Amendment to the Drawings

"Isolation of I2C Buses in a Multiple Power Domain Environment Using Switches"

Docket No.: 3PD-M-8504 US

FIG. 1

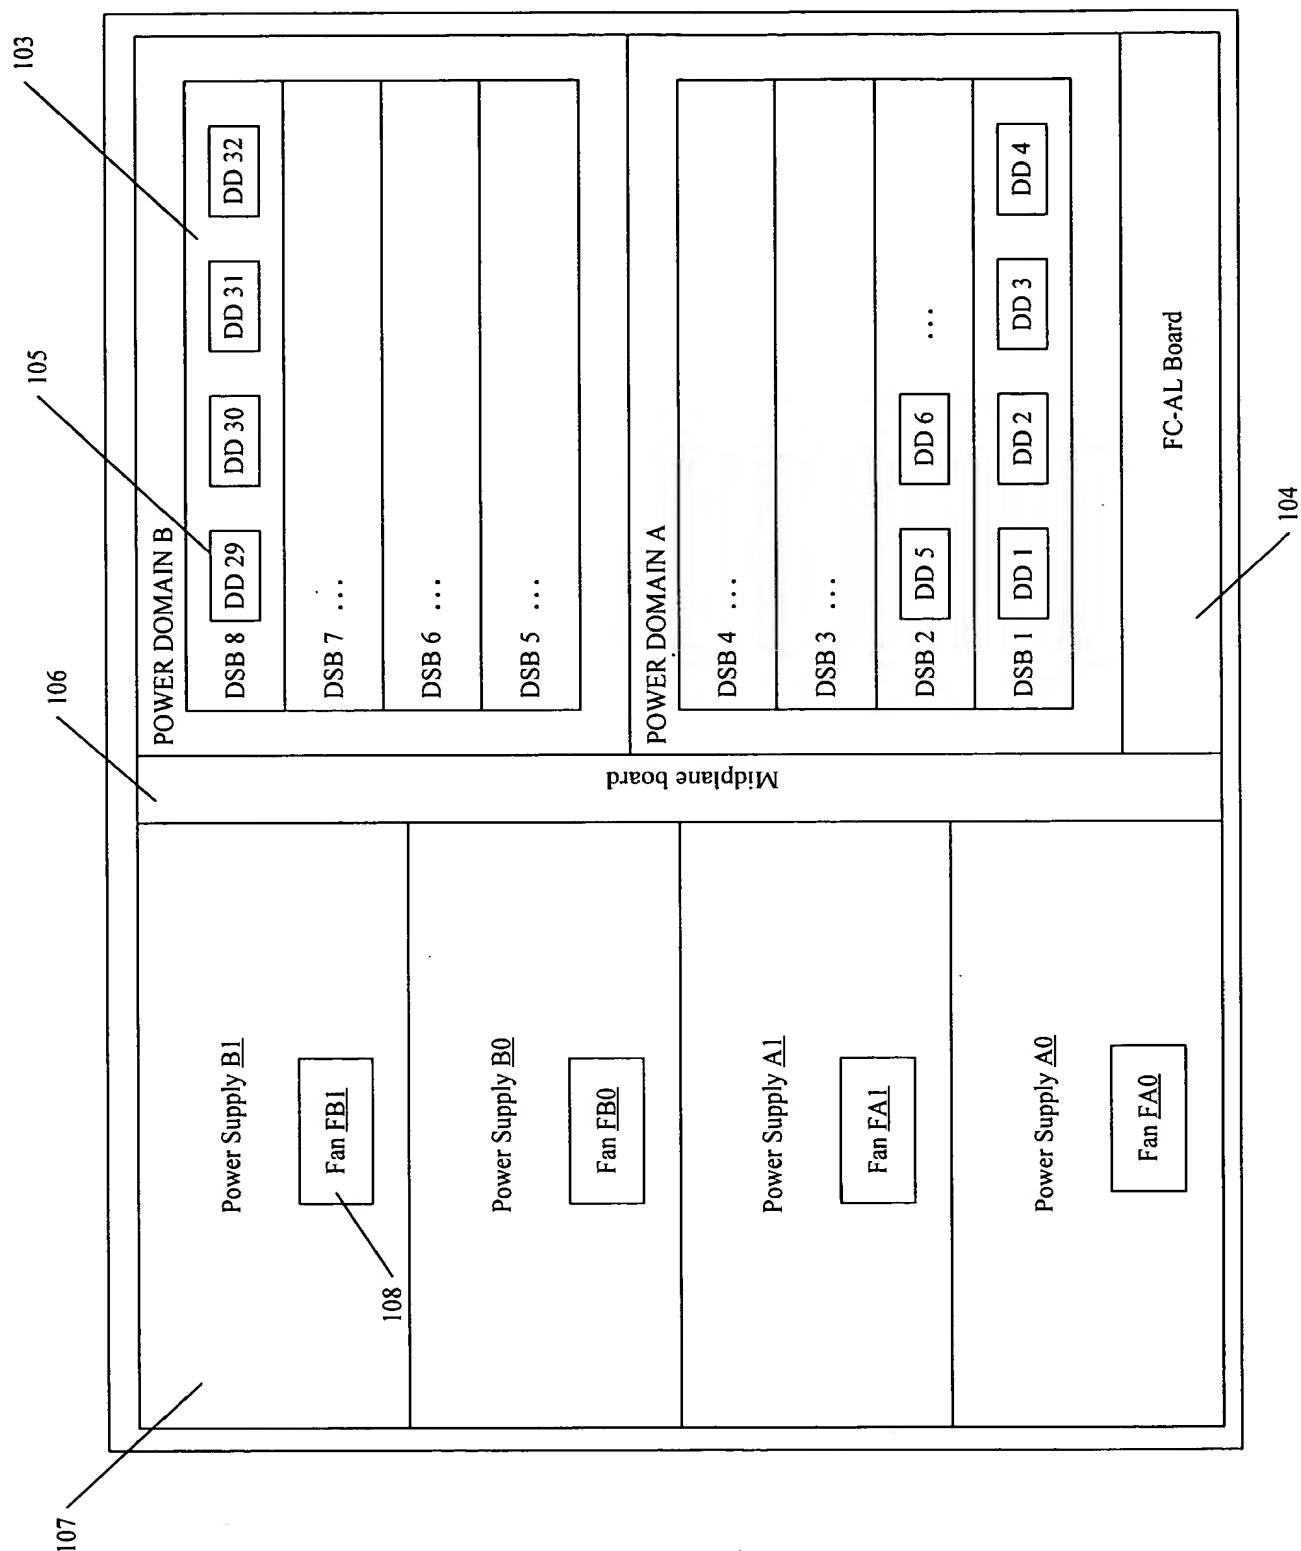
In Fig. 1, "Fan FB1" in power supply B0 has been changed to --Fan FB0--, "Fan FB1" in power supply A1 has been changed to --Fan FA1--, and "Fan FB1" in power supply A0 has been changed to --an FA0--.

Replacement sheet 2/11

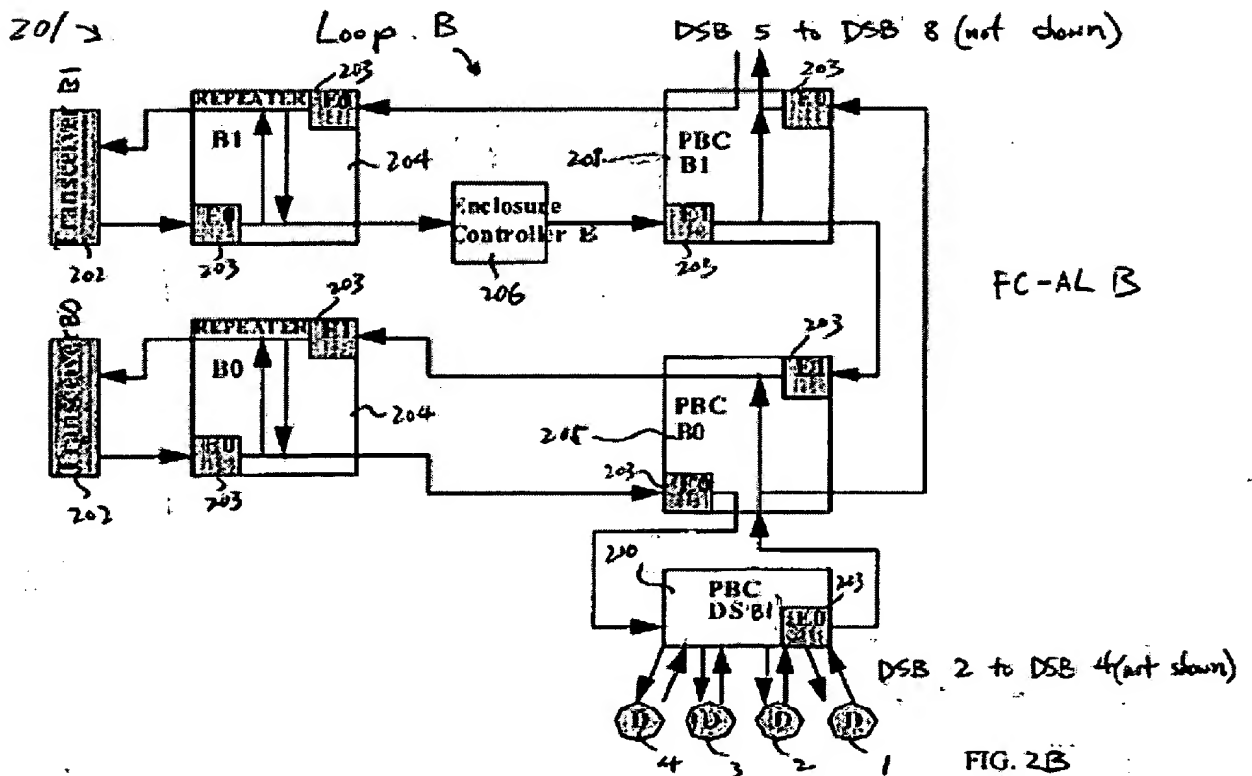
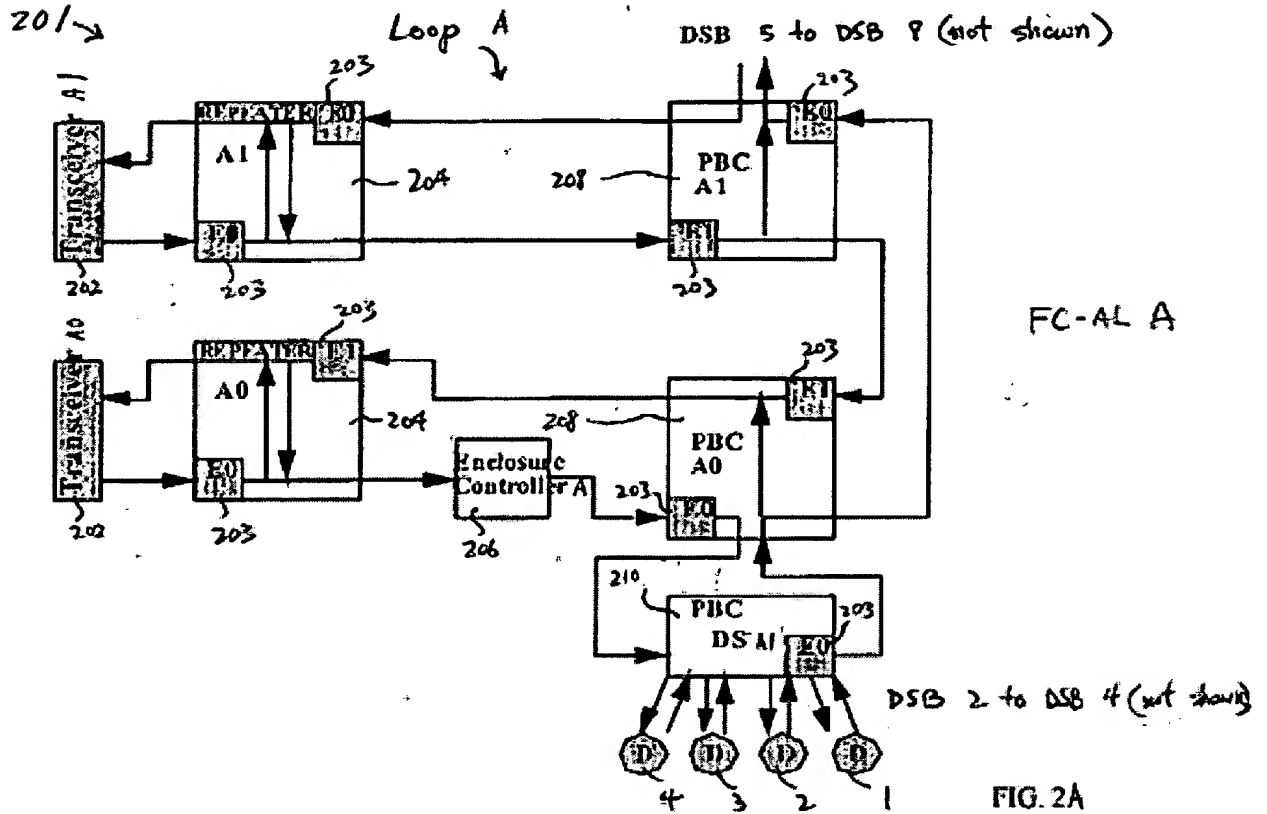
In Figs. 2A and 2B, reference numeral 201 has been added.

FIG. 4A

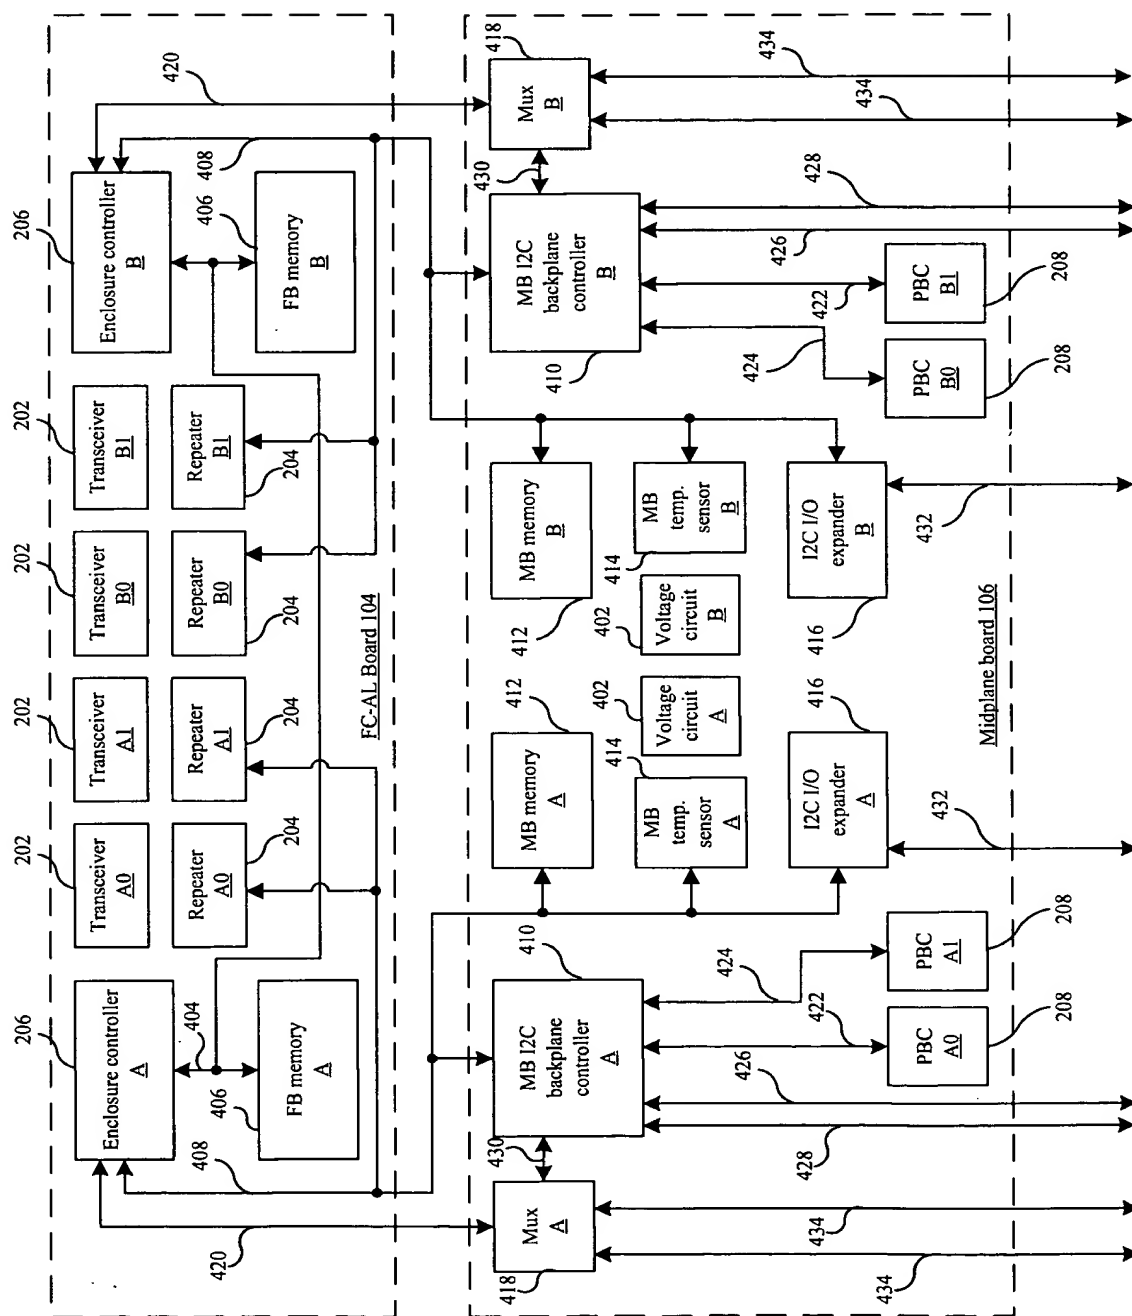
In Fig. 4A, reference numeral 404 has been added.

FIG. 7A

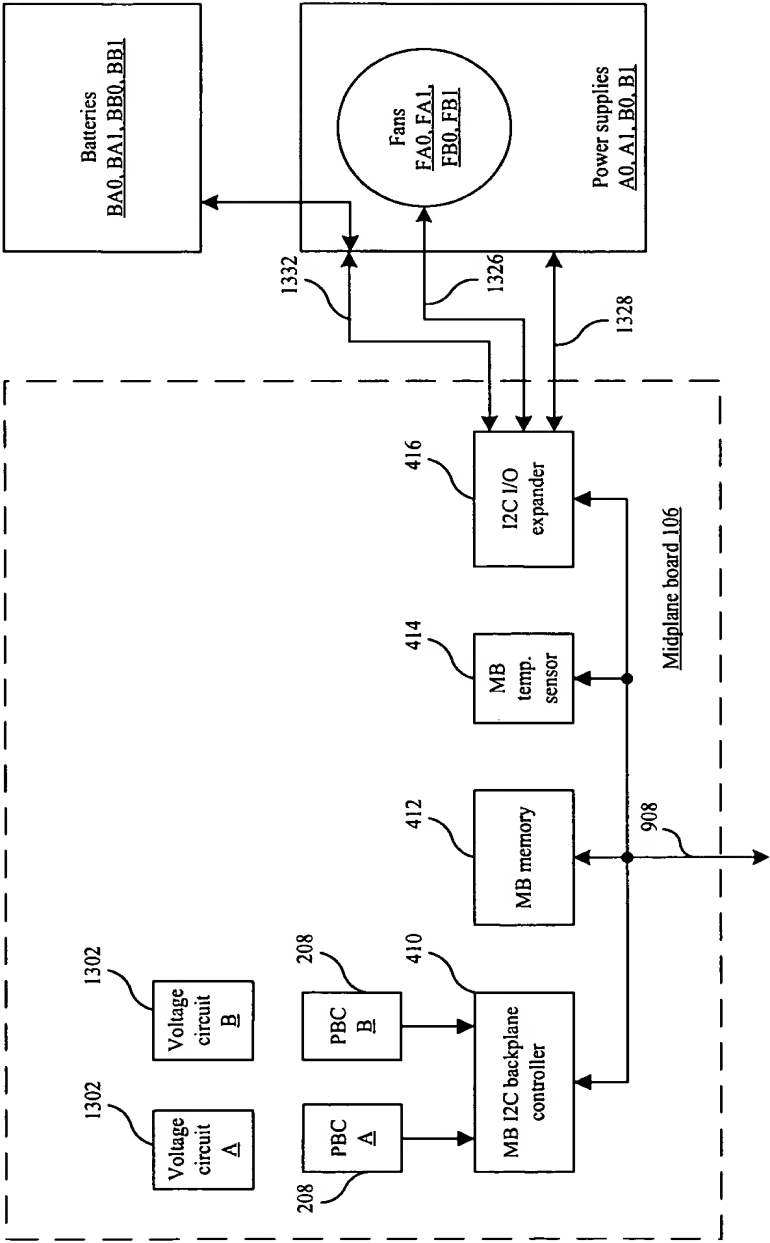
In Fig. 7A, reference numeral "Midplane board 106" has been added.

FIG. 7B

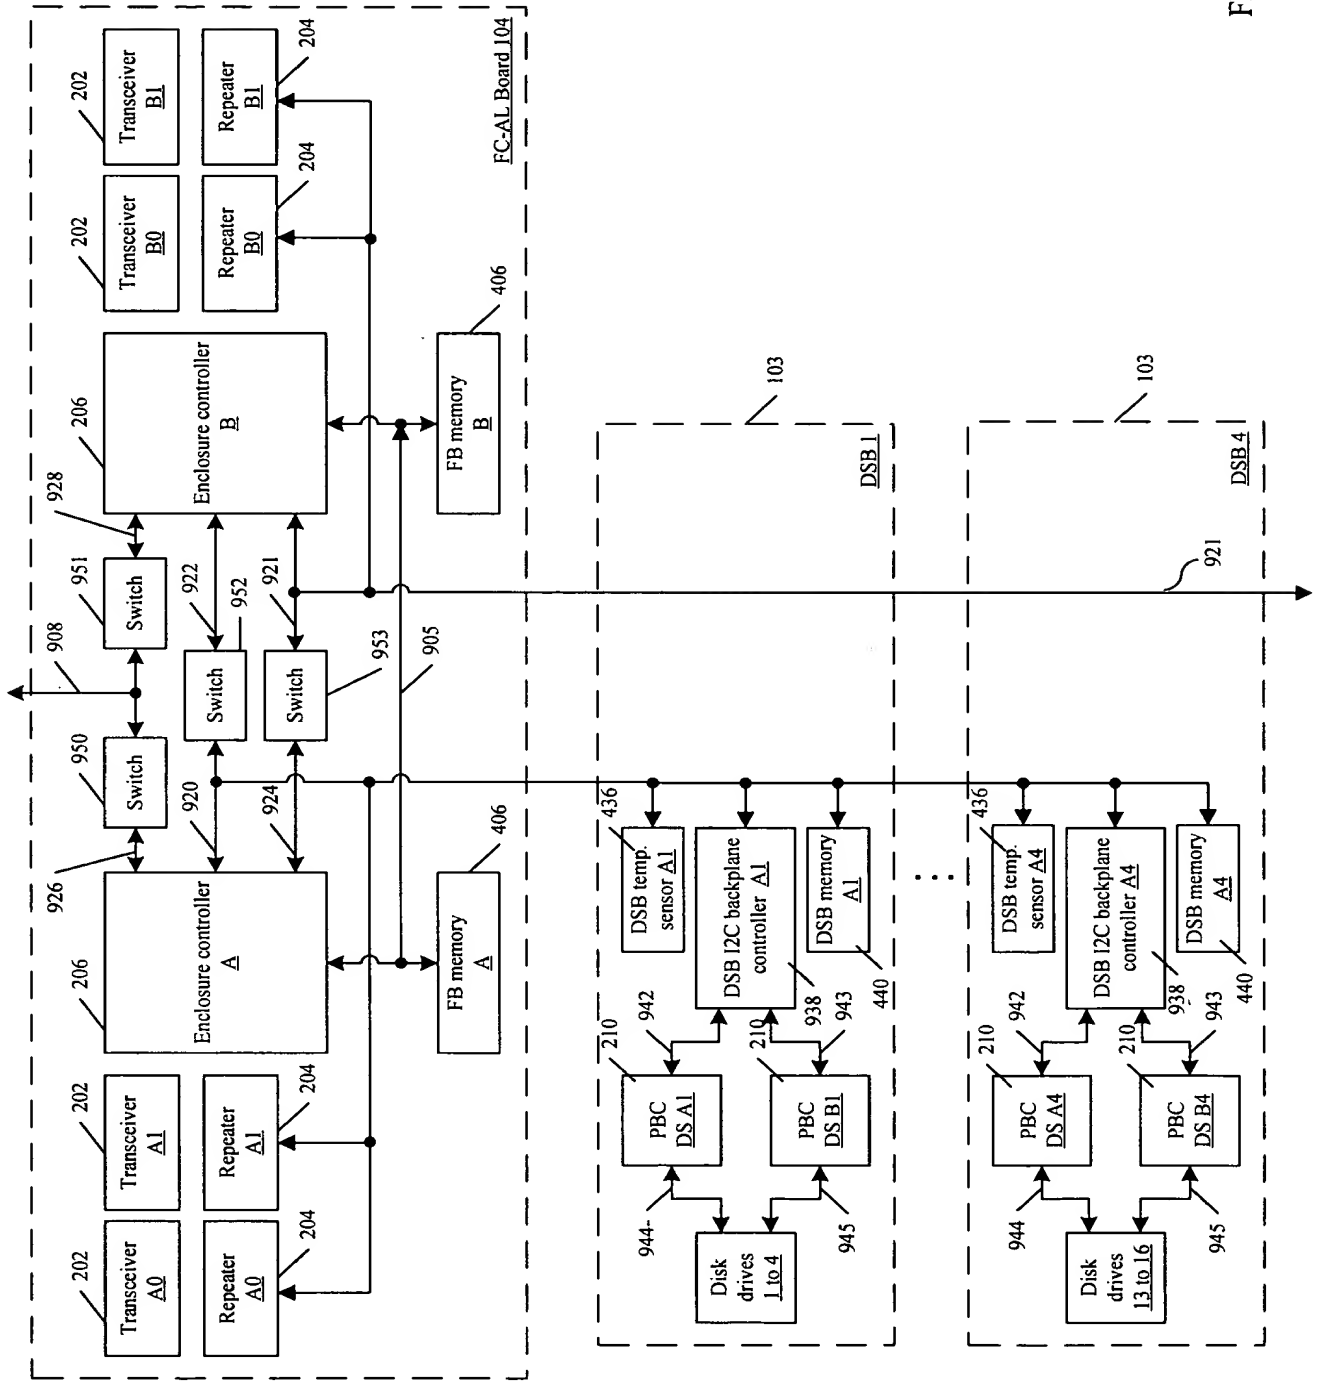
In Fig. 7B, reference numeral "Disk drives 1 to 3" has been changed to --Disk drives 1 to 4--.
